Re: Septic System Alteration Waiver  
Municipality: Clinton Township  
Block: 82.17 Lot: 39  
Location: 8 Fairview Dr.

This department has septic alteration plans dated September 29, 2021 designed by Douglas Fine, PE, to correct a malfunctioning system to an existing 4 bedroom dwelling with no expansion as stated on the application. The design is in full conformance with 7:9A "Standards for Individual Subsurface Sewage Disposal Systems" except for the following waiver requests that will need to be acted on by the Board:

# SEPTIC SYSTEM ALTERATION DESIGN

BLOCK 82.17, LOT 39

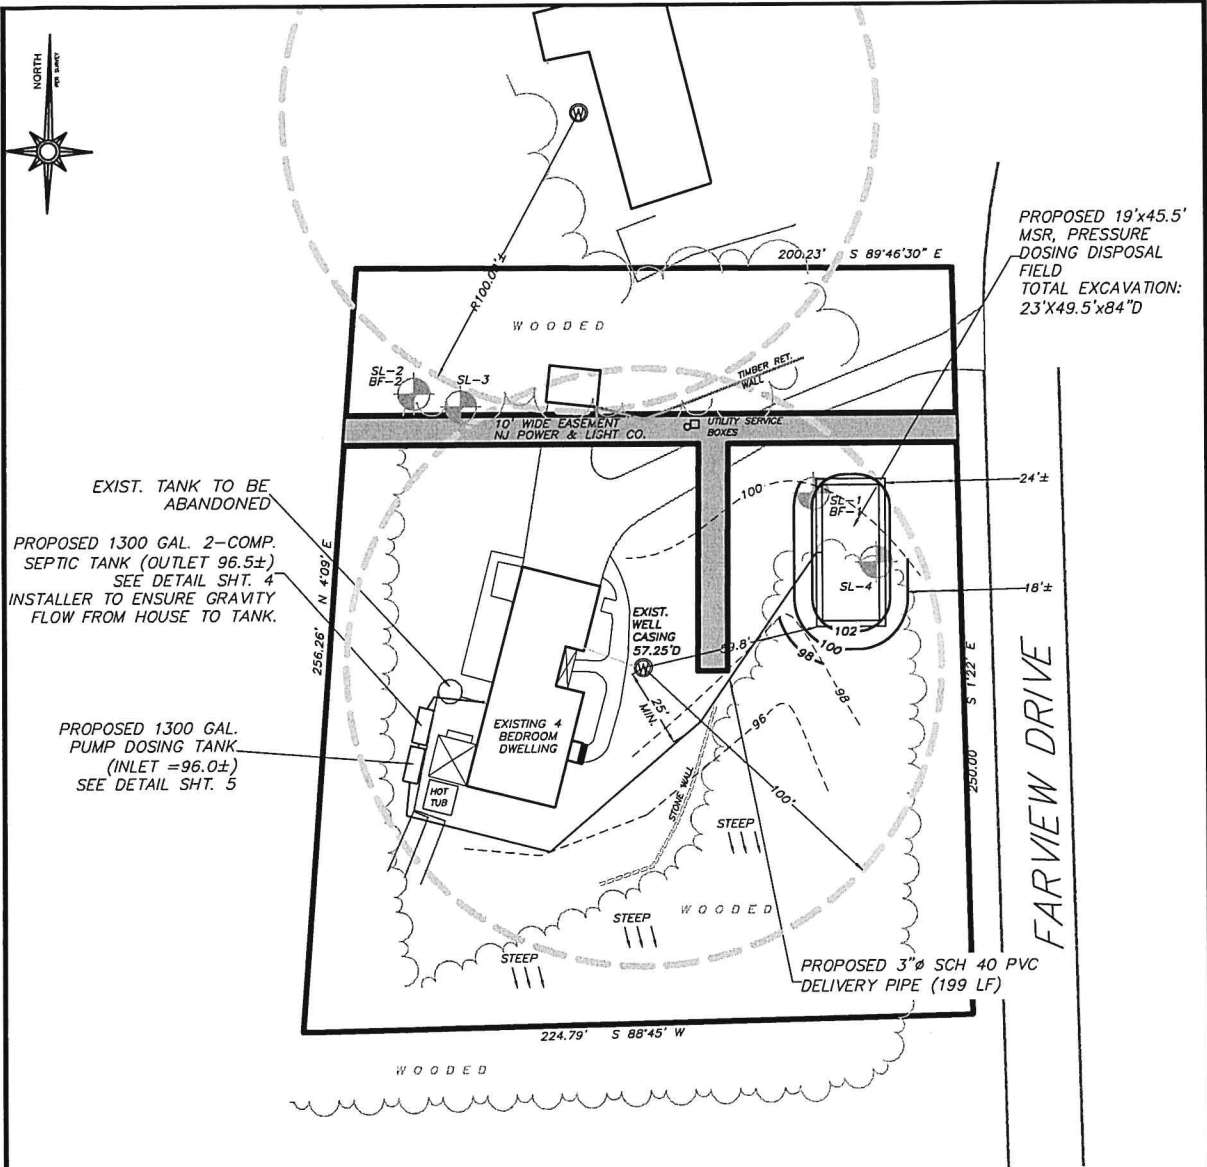
1. The proposed disposal bed will be only 59.8 feet from the existing well, which does not meet the minimum 100 foot set back requirement by code. As per 7:9A-4.3, the distance can be reduced to 50 feet provided there is 50 feet of casing in the well. A letter from D+L Pump Company dated July 28, 2021 states that there is 57 feet of casing in the well, therefore the Board can approve the waiver request.

Since this is a malfunctioning system, and according to 7:9A 3.3(e) 2 i and ii, and the system is closer to being in full conformance with the chapter than the original system, the Board can approve waiver request.
